REQUEST FOR INFORMATION **DATE:** December 05, 2016 **NO.:** RFI-370

Project Name: 15051-Webster University Interdisciplinary Science Building Project No.: 15051

Subject: Additional guard rail details at retaining wall

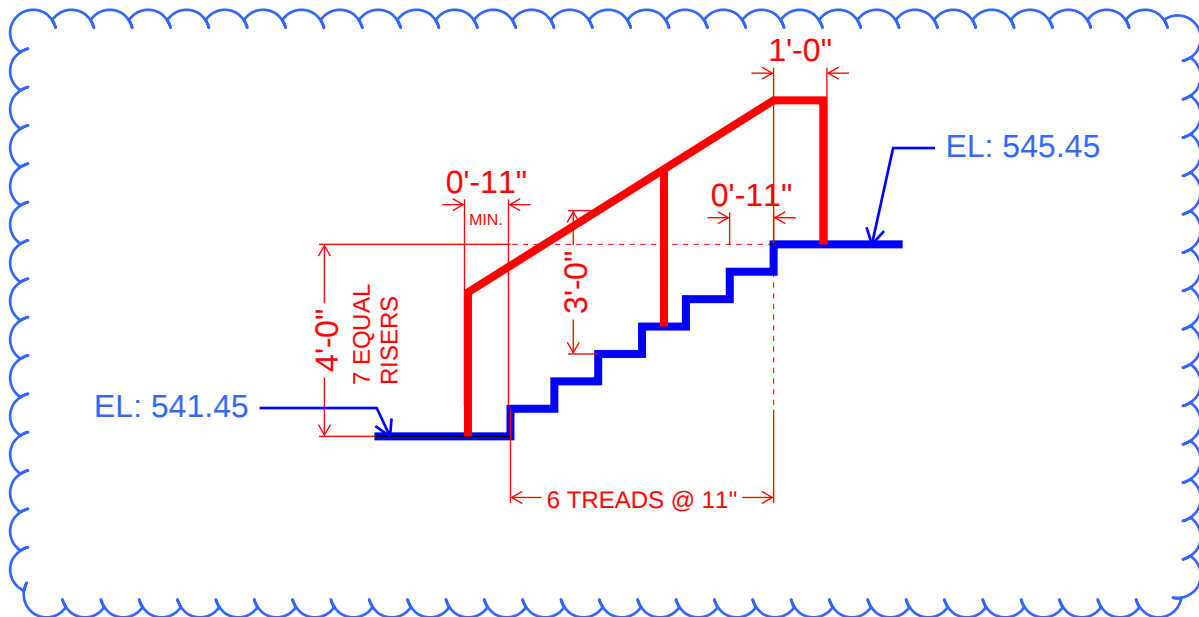
1. Please advise rail details to be used for the 3'-6" high railings, shown north and south of the Emergency Generator (near lines F – 8). **USE RAILING DETAILS ON 1/A0508.E. COLOR TO MATCH CURTAINWALL MULLIONS.**
2. Please advise the details, extents and elevations for the 'long' 3'-6" high rail' shown approximately 10'-9" east of line 8, from line C to nearly line F. (Ref: Paric RFI #291) **PROVIDE RAILING PER RAILING DETAILS ON 1/A0508.E. COLOR TO MATCH CURTAINWALL MULLIONS.**
3. Please advise sections and details to be used for the concrete steps with ~~painted~~ galvanized rails shown near lines C – 8. **RAILING DETAILS SIMILAR TO RAILINGS ON 1/A0505 & 3/A0505. COLOR TO MATCH CURTAINWALL MULLIONS. RAILING TO BE POWDER COATED GALVANIZED STEEL.**

**LEVEL 01 AREA A FLOOR
PLAN**

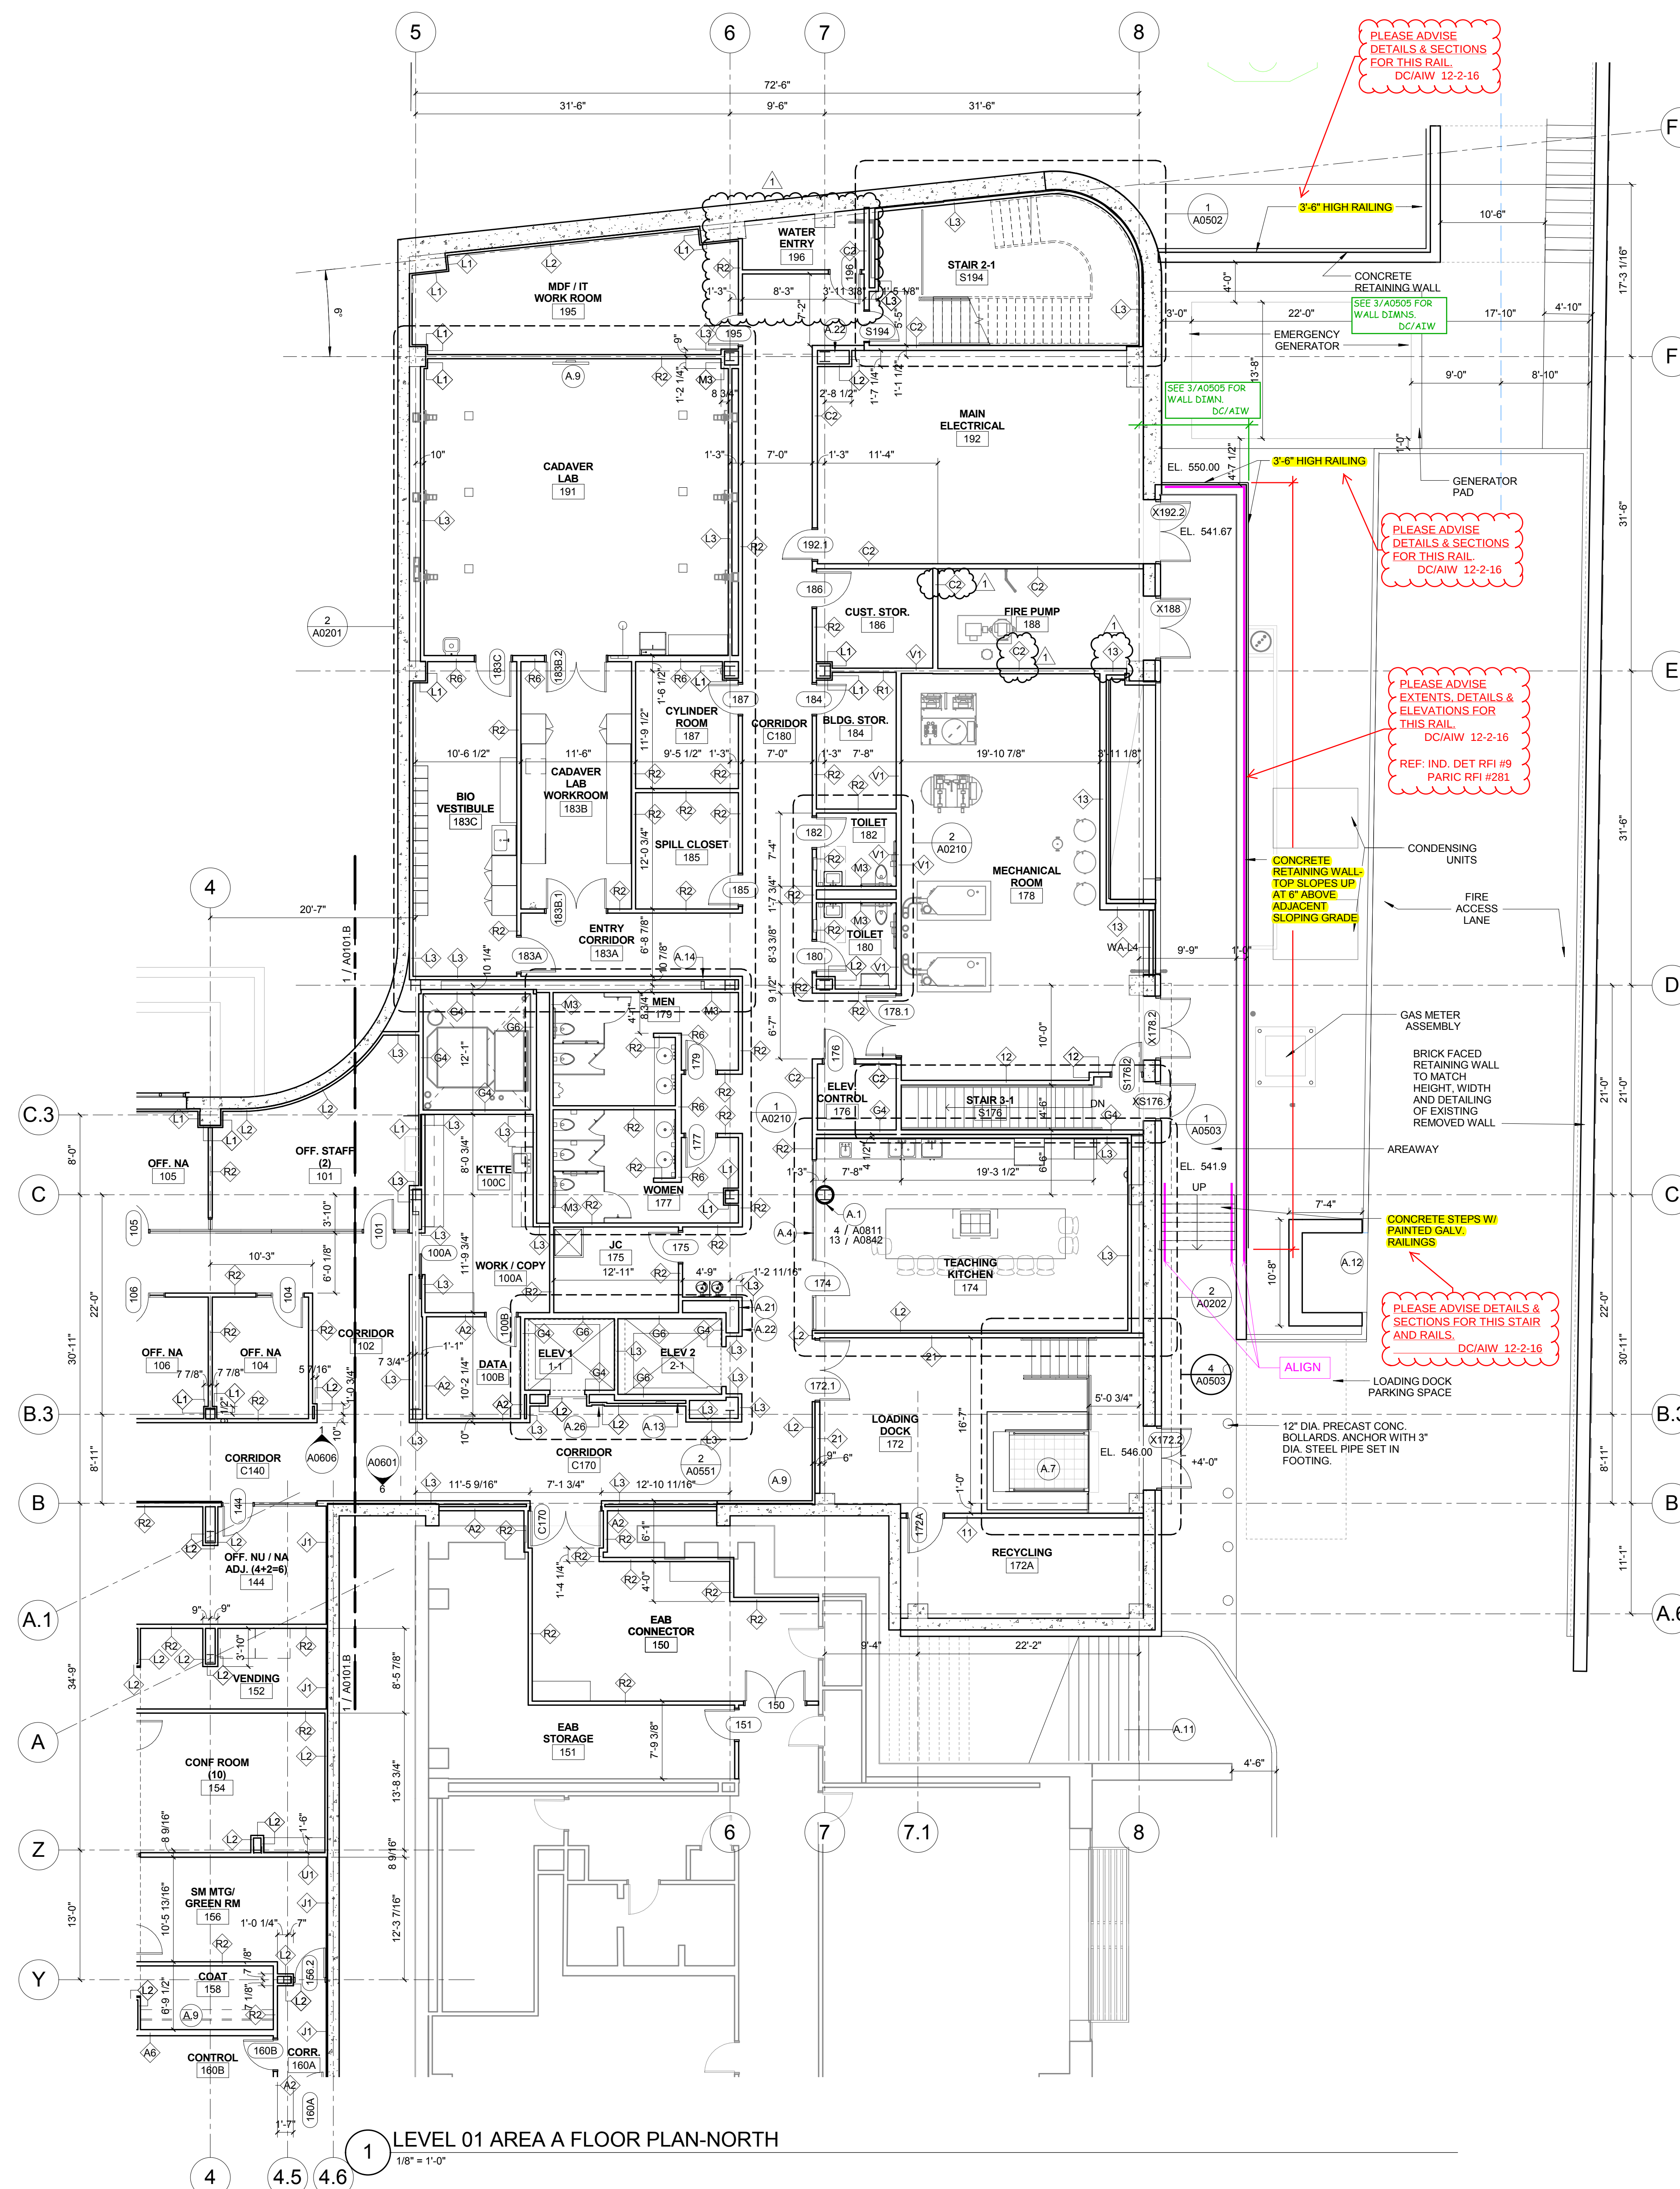
See attached markup.

RAILINGS AT COL. LINE C & 8:

RAILING DETAILS SIMILAR TO RAILINGS ON 1/A0505 & 3/A0505.

COLOR TO MATCH CURTAINWALL MULLIONS.

RAILING TO BE 1 1/2" O.D. POWDER COATED GALVANIZED STEEL.
